Vermont State Hospital
Brooks Building
Waterbury, Vermont

Psychiatric Facility Safety and Security Review

Based on an Inspection that took place on February 21, 2006

Vermont State Hospital (VSH)
Brooks Building
Psychiatric Units
Safety and Security Inspection

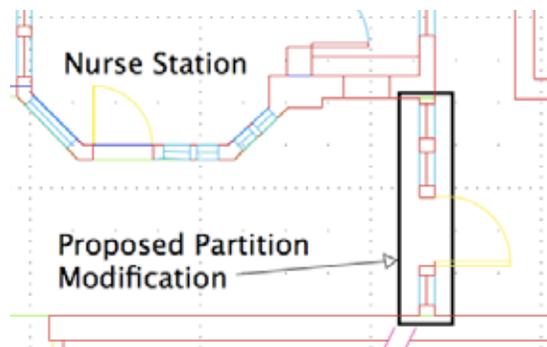
Chain Link Partition: This impression is reinforced by a "chain link" partition and door at the end of the corridor, at the point of entry onto the unit.

Recommendation (EE): Replace the Chain Link Partition with a hollow metal and glass partition similar to the access to the Rehab Unit.
